Terminal block substitute for TD-700T, TD-9000T and TD-SC1

28 November 2022

TEAC Corporation

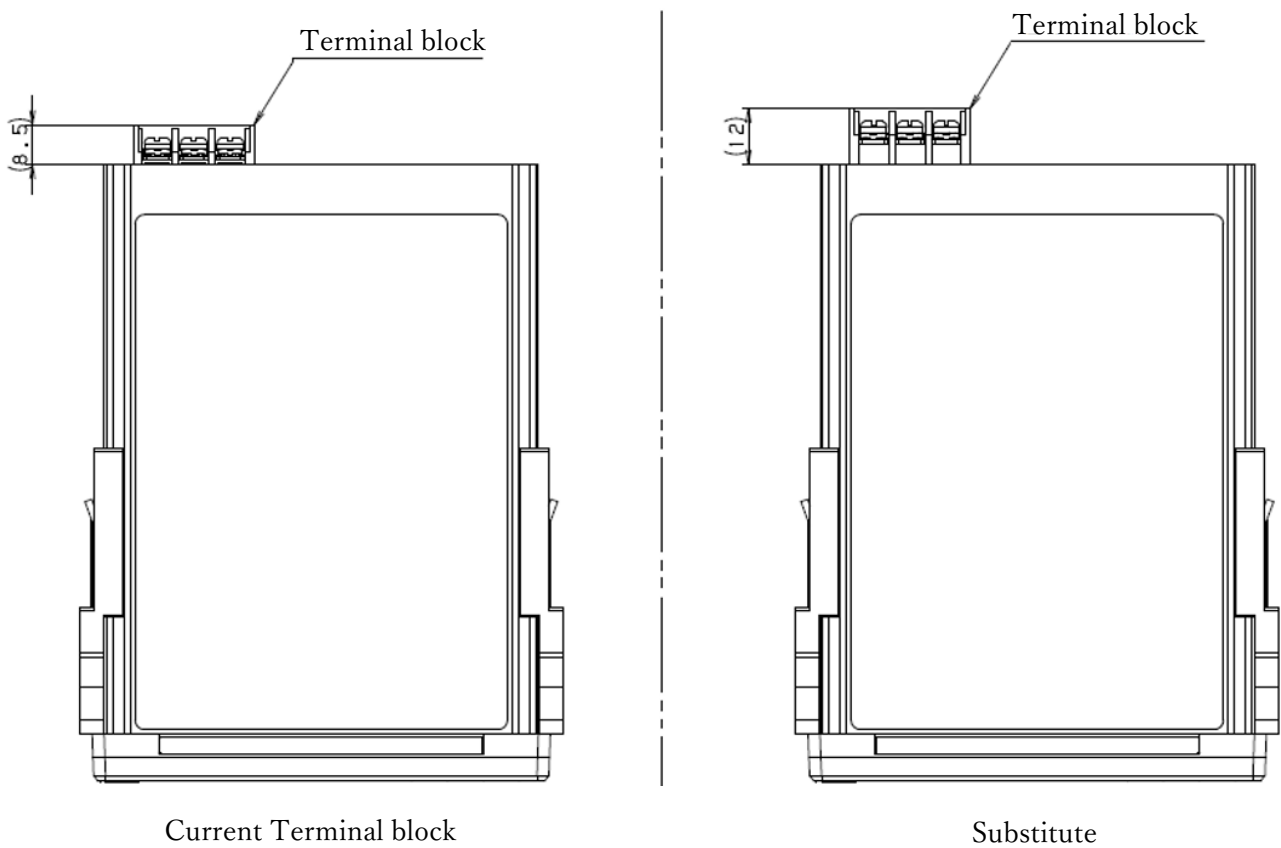
Recently, a stable supply of some parts has become difficult, especially the terminal block for TD-700T, TD-9000T, and TD-SC1 have become more difficult.

So we have decided to adopt a substitute for them.

But the size of the substitute is a little bit different from the current one.

- TD-700T

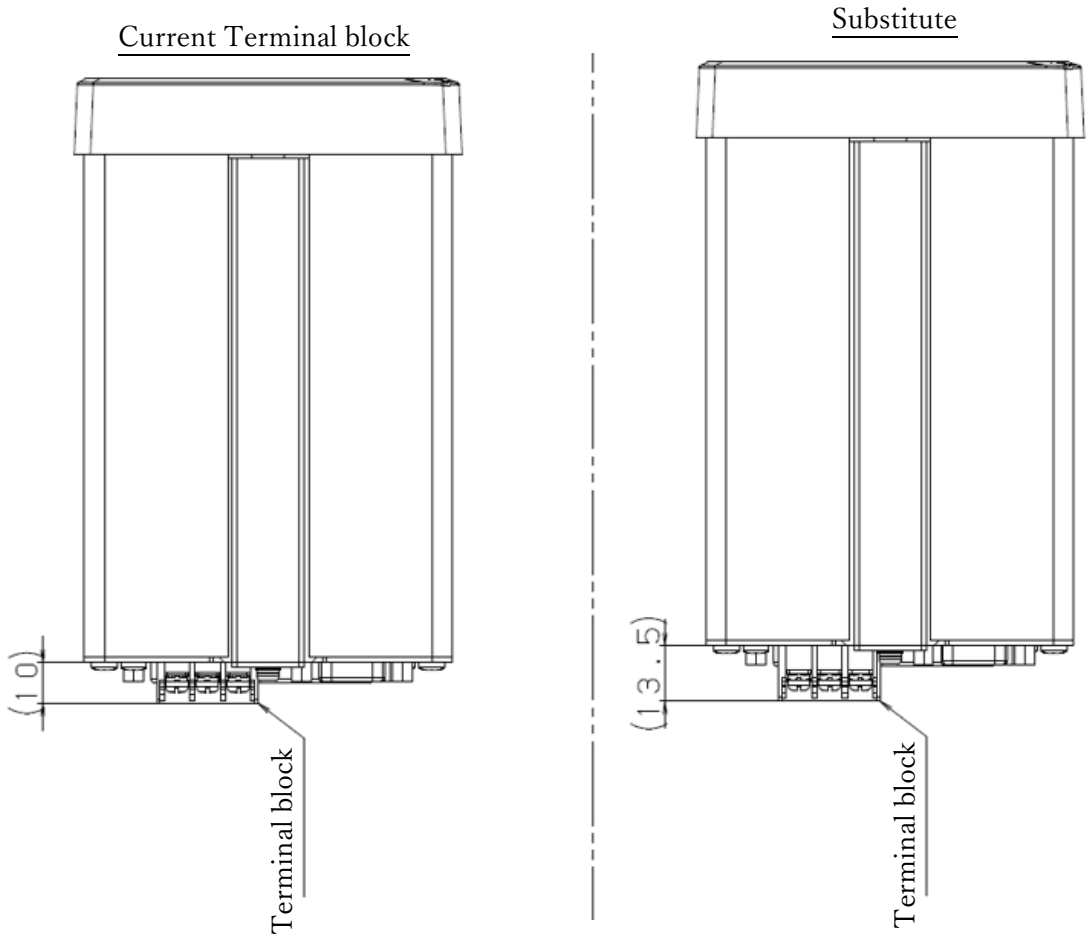
Please see the following drawings, it's 3.5mm longer in depth than the current one.

We'll delete the dimensions of the terminal block on the IFU and revise it soon.
